ADDENDUM NO. 1 TO PROJECT NO. M2651

**HAZARDOUS MATERIAL WORK, HVAC WORK, ELECTRIC WORK
 REPLACE CONDENSATE & STEAM LINES FROM THE POWER PLANT, BLDG NO. 24 TO
 BLDG. NOS. 2 & 3
 GREEN HAVEN CORRECTIONAL FACILITY
 ROUTE 216
 STORMVILLE, NY**

October 18, 2012

SHEET TITLE: **TUNNEL SECTION '2'**

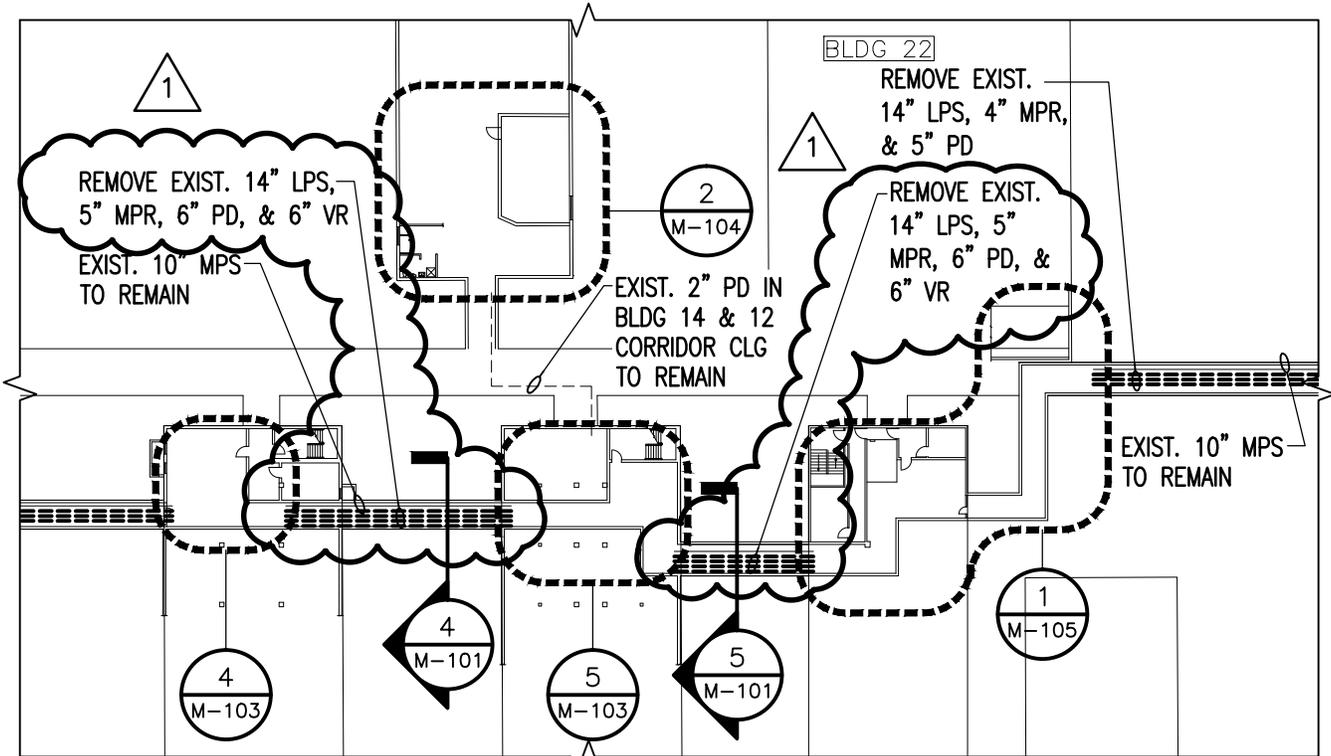
- 5) Drawing M-101, TUNNEL PIPING REMOVAL PARTIAL SITE PLAN AND SECTIONS
REVISE 2/M-101 to show the removal of the existing 5” MPR and 6” PD. Refer to attached drawing AD1-M1
- 6) Drawing M-101, TUNNEL PIPING REMOVAL PARTIAL SITE PLAN AND SECTIONS
ADD to 1/M-101 the vacuum return lines which are being removed in plan view. Refer to attached drawings AD1-M2 and AD1-M3.
- 7) Drawing M-102, TUNNEL PIPING REMOVAL PARTIAL SITE PLAN AND SECTIONS
ADD to 1/M-102 the vacuum return lines which are being removed in plan view. Refer to attached drawings AD1-M4 and AD1-M5.
- 8) Drawing M-201, TUNNEL PIPING PARTIAL SITE PLAN AND SECTIONS
REVISE 1/M-201 note by the main exterior to wall to read, “Provide 4” PD Piping thru 30” thick concrete wall. Patch unused wall openings w/conc. (equip pad mix).”

1 ADDED 6" PD AND 5" MPR

| SHEET TITLE: TUNNEL PIPING REMOVAL PARTIAL SITE PLAN | |

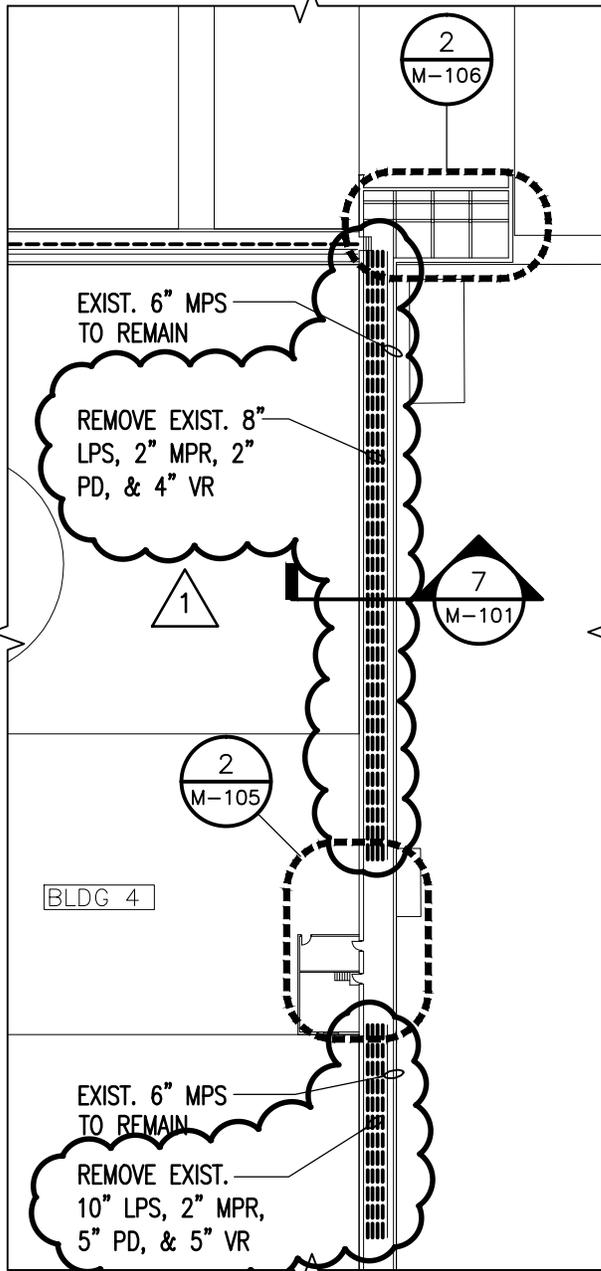
1 ADDED 6" VR

| SHEET TITLE: TUNNEL PIPING REMOVAL PARTIAL SITE PLAN | |

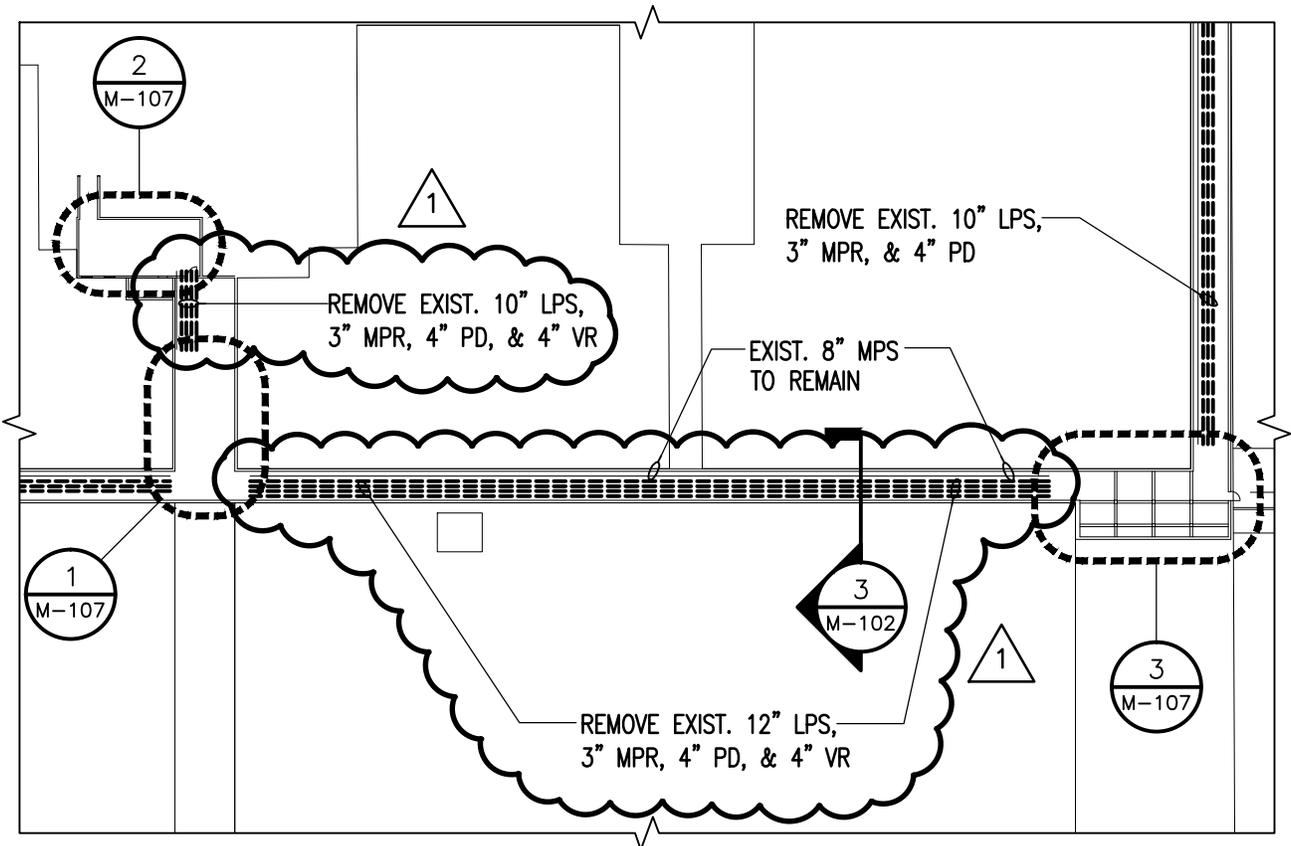
1 ADDED 4" VR AND 5" VR

SHEET TITLE:
TUNNEL PIPING REMOVAL PARTIAL SITE PLAN

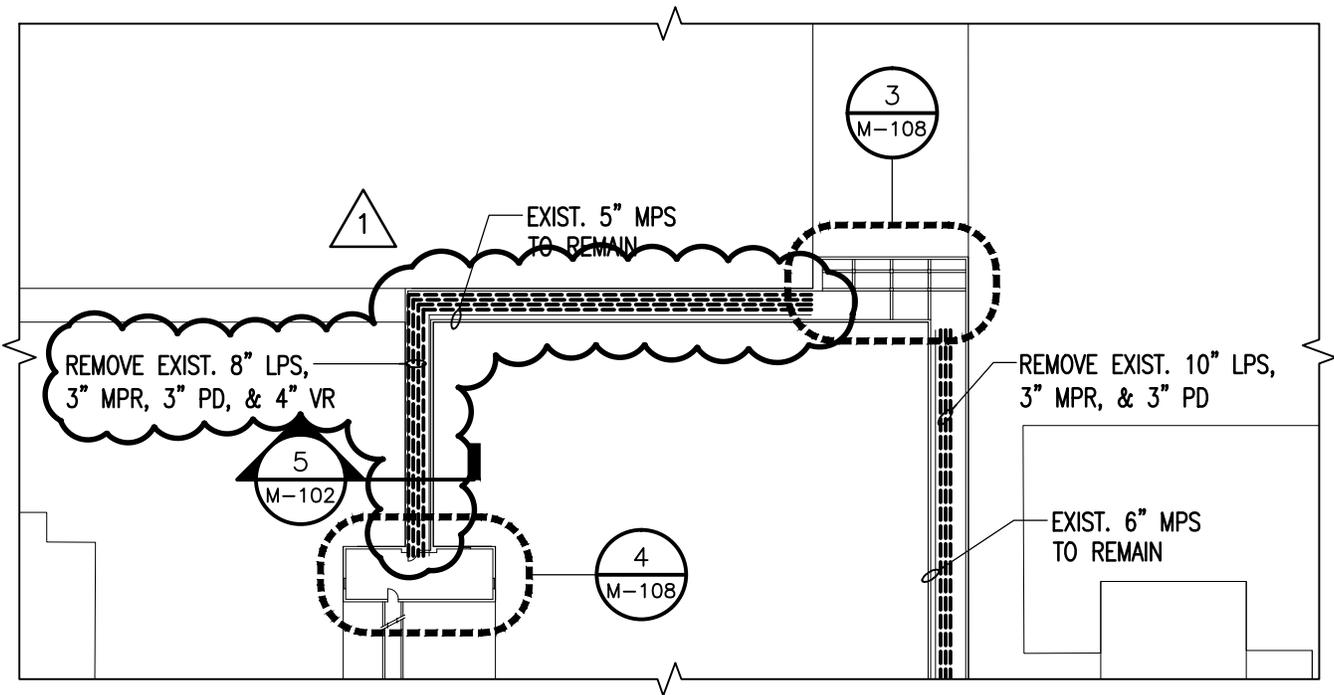
1 ADDED 4" VR
